STAFF RECOMMENDATION
1813 Fifth Avenue North
November 18, 2015

Application: Demolition; New construction—infill and outbuildings

Description of Project: Application is to demolish a non-contributing structure and to construct a new duplex infill and two three hundred and fifty square foot (350 sq. ft.) garages.

SITE PLAN (1)

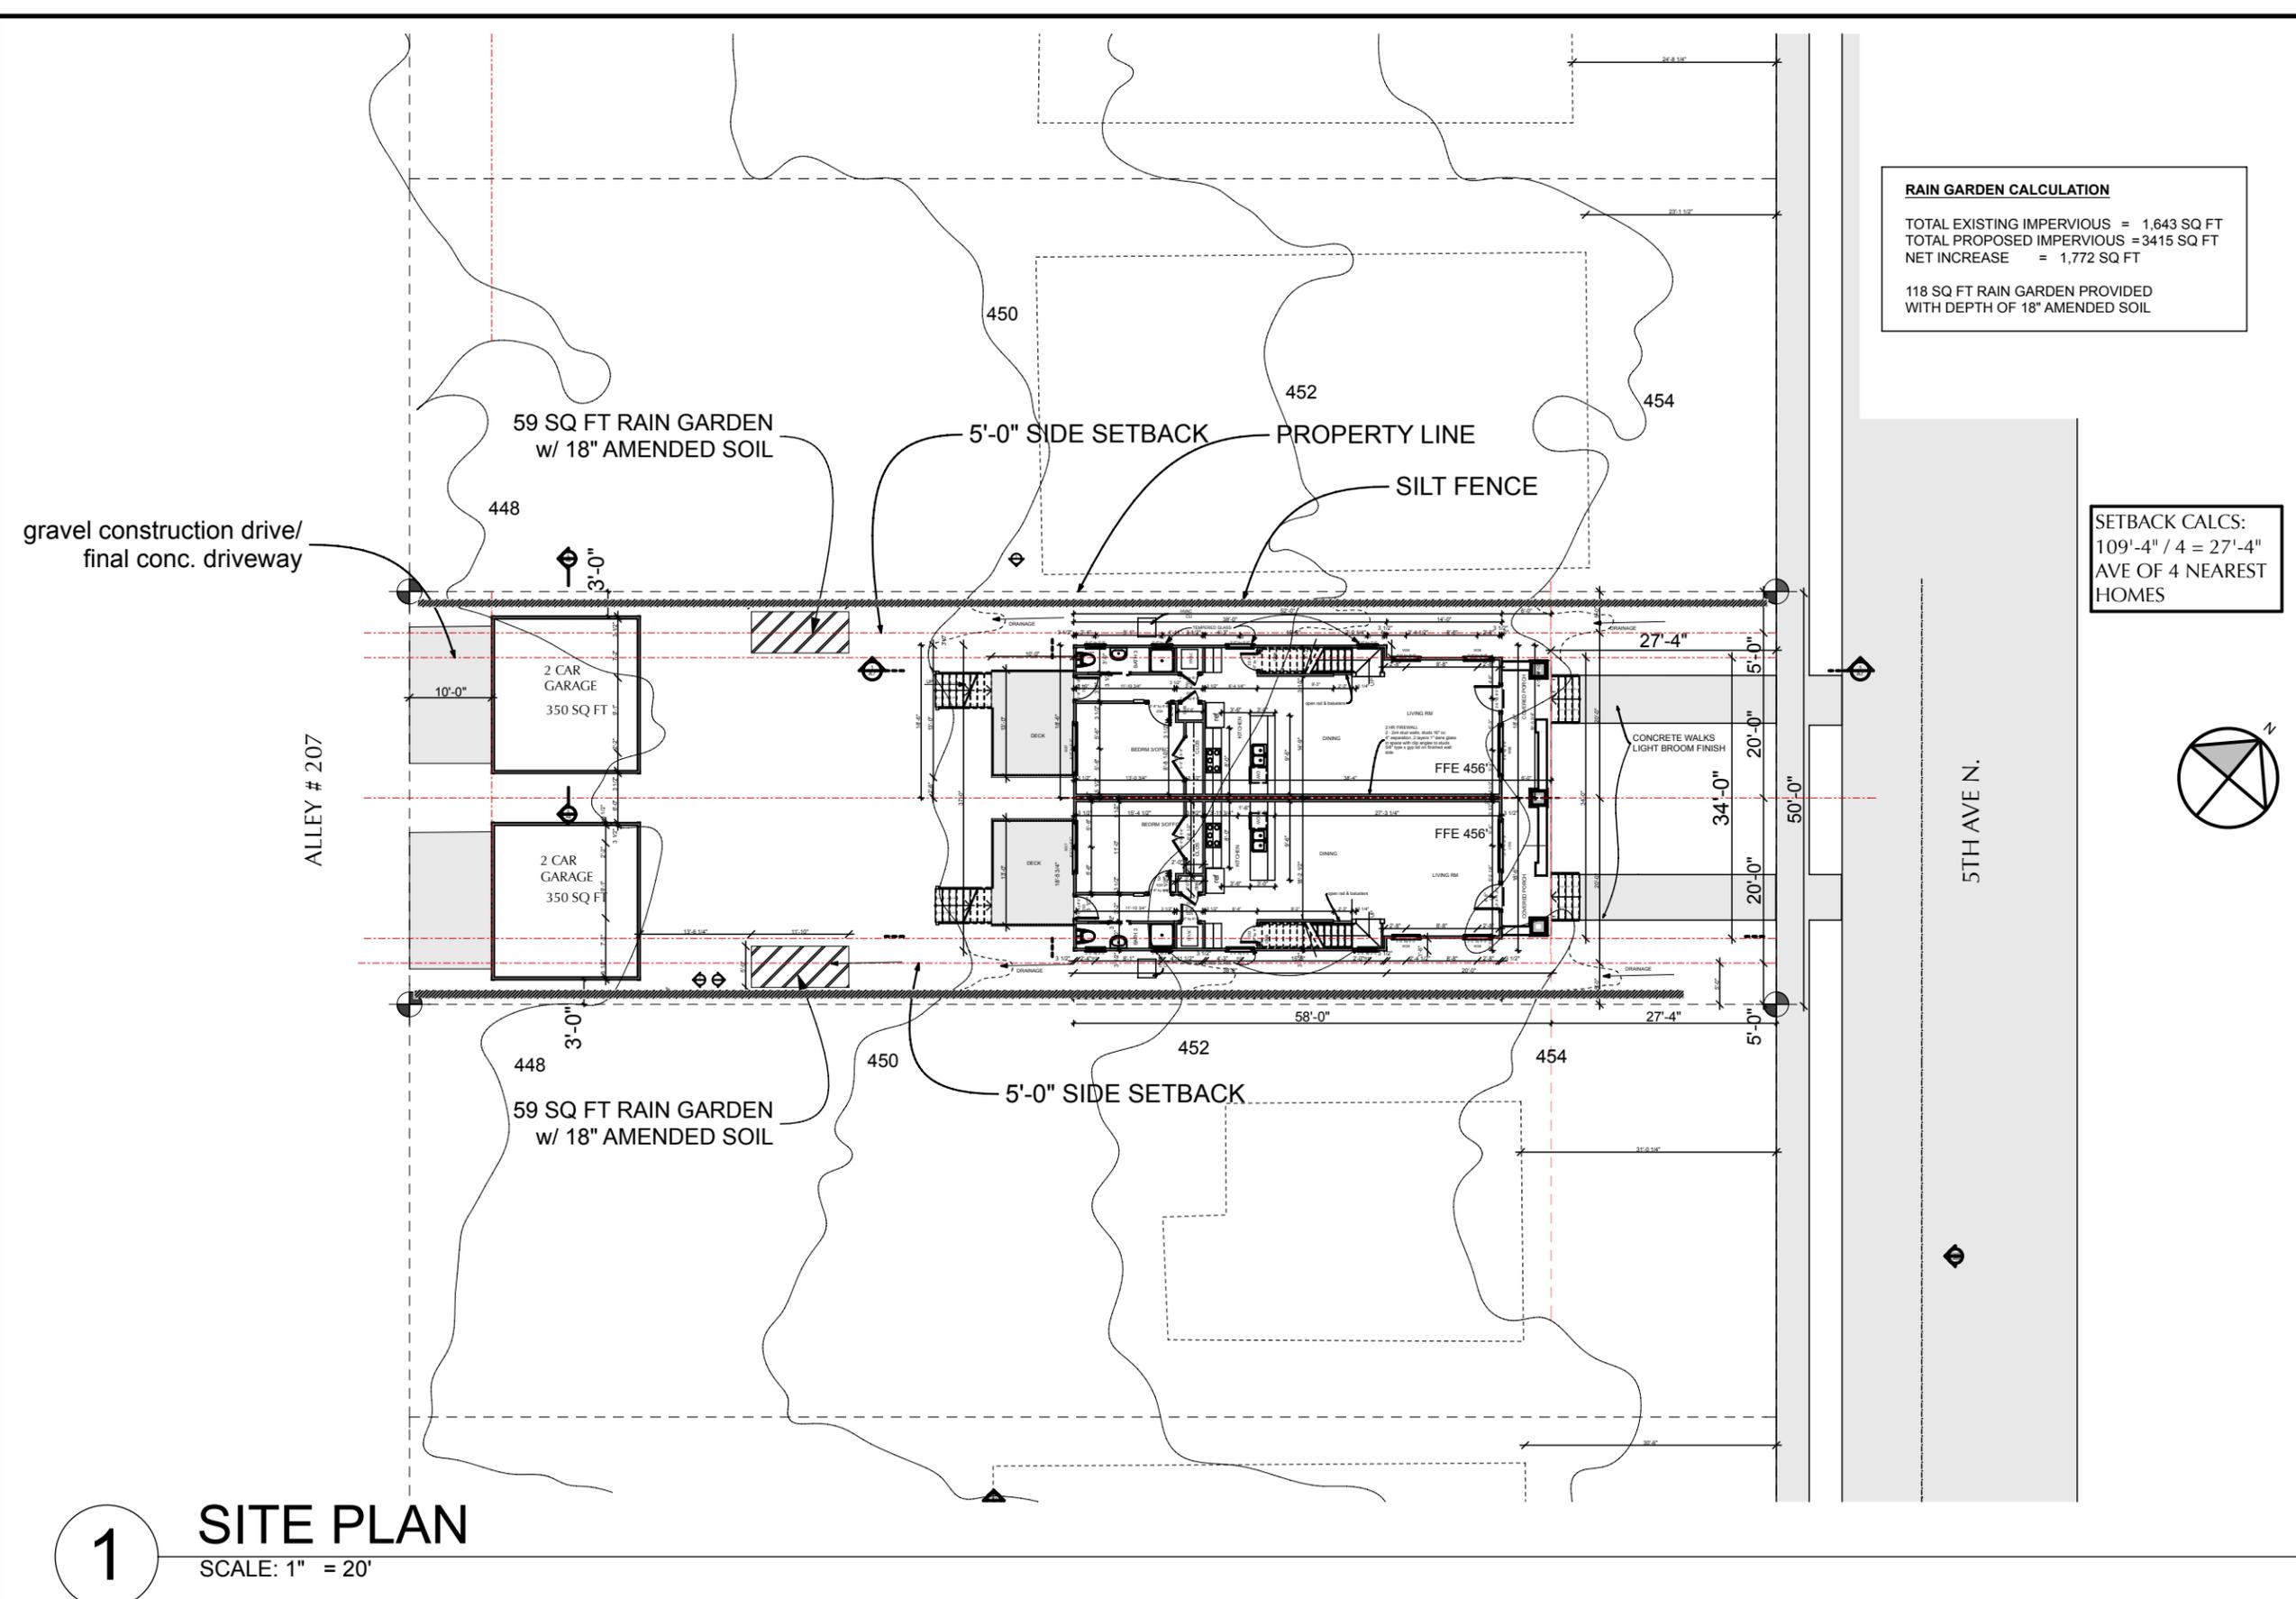
Setback & Rhythm of Spacing: The duplex's lot is fifty feet (50') wide, which is a typical lot width for the area. The duplex will be centered on the lot, and meets all base zoning requirements for setbacks. It is a minimum of six feet, six inches (6'6") from each of the side property lines, and over eighty feet (80') from the rear property line.

The front setback will be approximately twenty-seven feet, four inches (27'4") from the front property line. This is the average of the two adjacent setbacks; 1815 Fifth Avenue North is twenty-three feet (23') from the front property line, and 1811 Fifth Avenue North is thirty-one feet (31') from the front property line. Staff finds that the duplex's setback and rhythm of spacing meets Section III.C. of the design guidelines.

Appurtenances & Utilities: The site plan shows that each of the two HVAC units will be placed on the side facades, almost to the rear of the house. Staff finds that these locations are appropriate and meet Section III.I. of the design guidelines.

GARAGE (1)

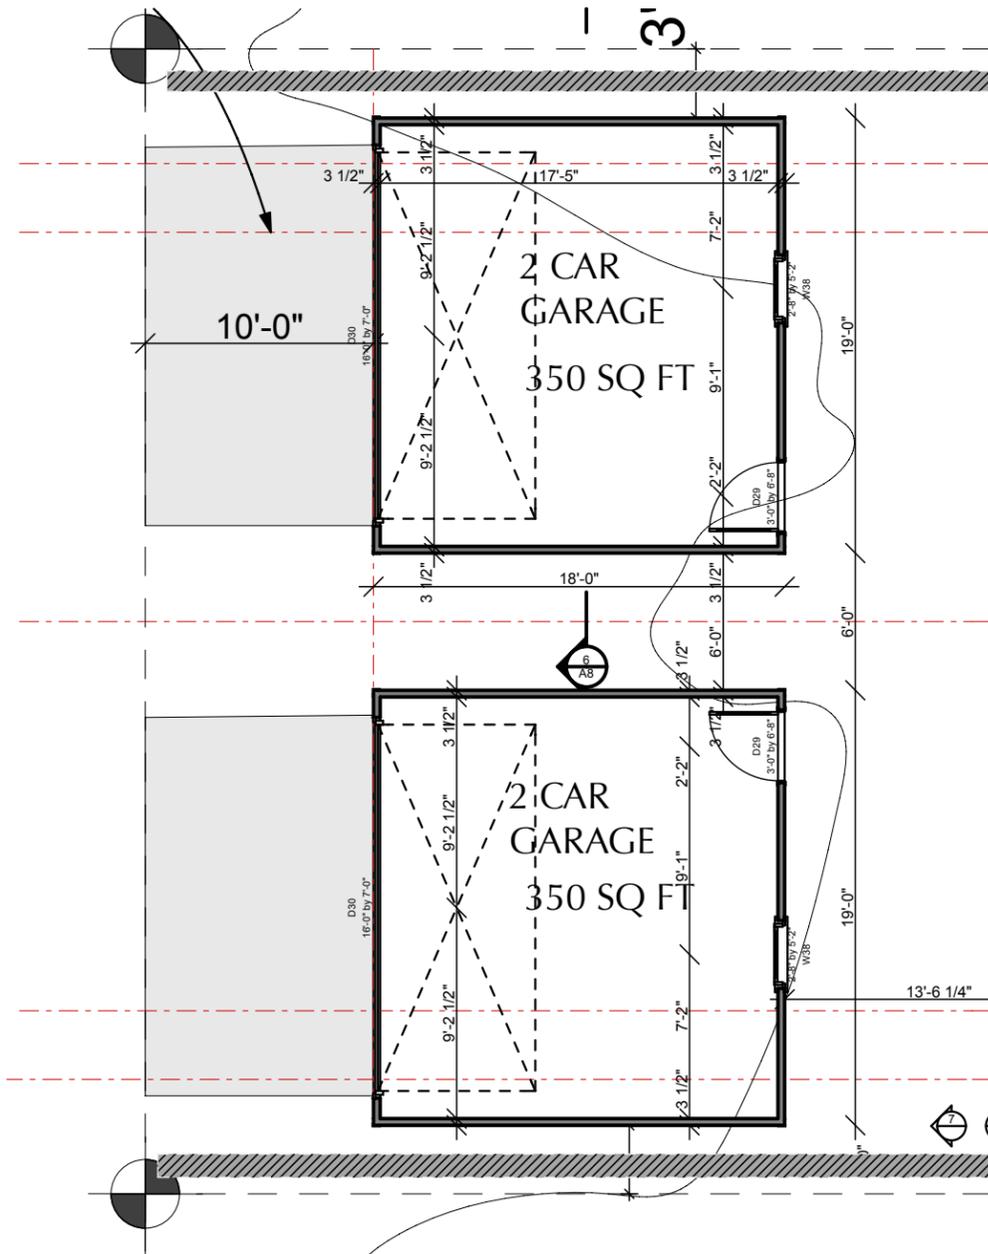
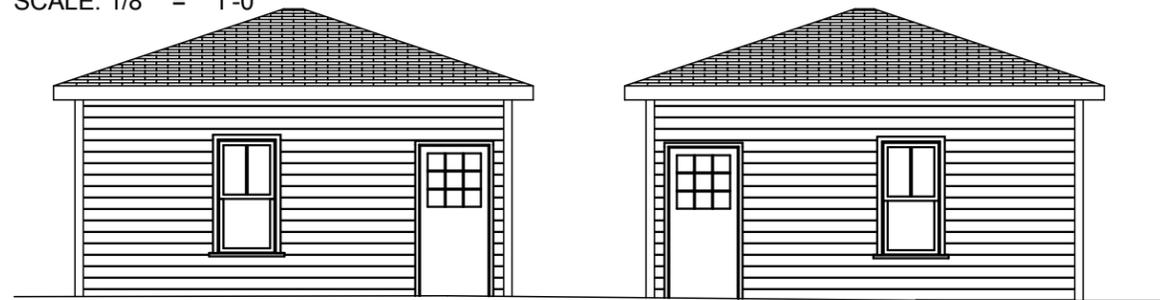
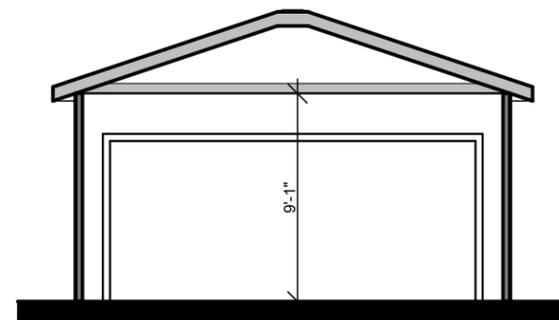
Outbuildings: The applicant is proposing to construct two separate, one-story garages that are three hundred and fifty-square feet (350 sq. ft.) each. See attached "Outbuilding Worksheet" for a full analysis of how the proposed outbuildings meet the design guidelines. The garages meet the base zoning setbacks, and will be accessed via the alley. The materials for the garages will mimic those of the duplex, and include five inch (5") cement fiberboard siding, fiberglass shingles, and a metal garage door. Staff finds that the proposed outbuildings meet Section III.H. of the design guidelines.
